REMARKS

The above amendments amend the drawing and specification to correct obvious errors and to improve clarity. No new matter is added. Attachment A shows the amendments made to the specification. Accompanying this response are (1) a request to amend the drawings and (2) a terminal disclaimer.

FIG. 1B

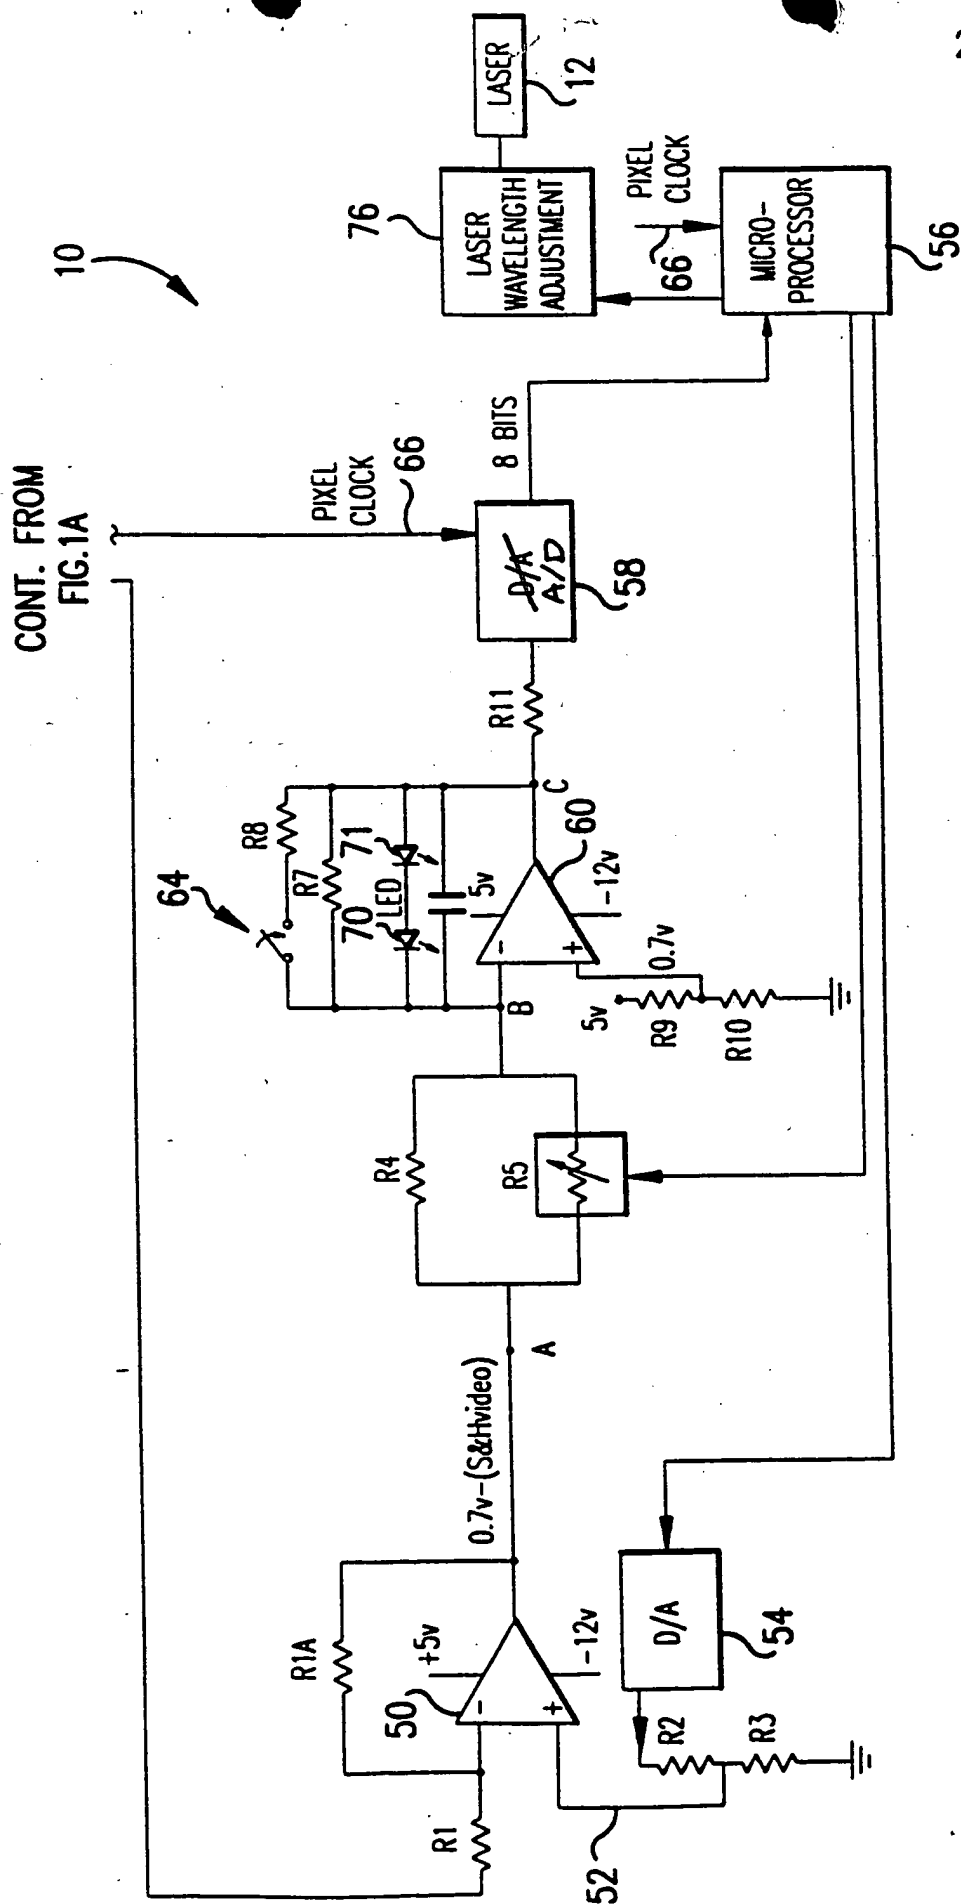
The Examiner objected to the drawings under 35 C.F.R 1.83(a) for failure to show every feature of the inventions specified in the claims. Due to a drafting error, the A/D converter 58 illustrated in FIG. 1B was marked as "D/A" instead of as "A/D" as described in the specification.
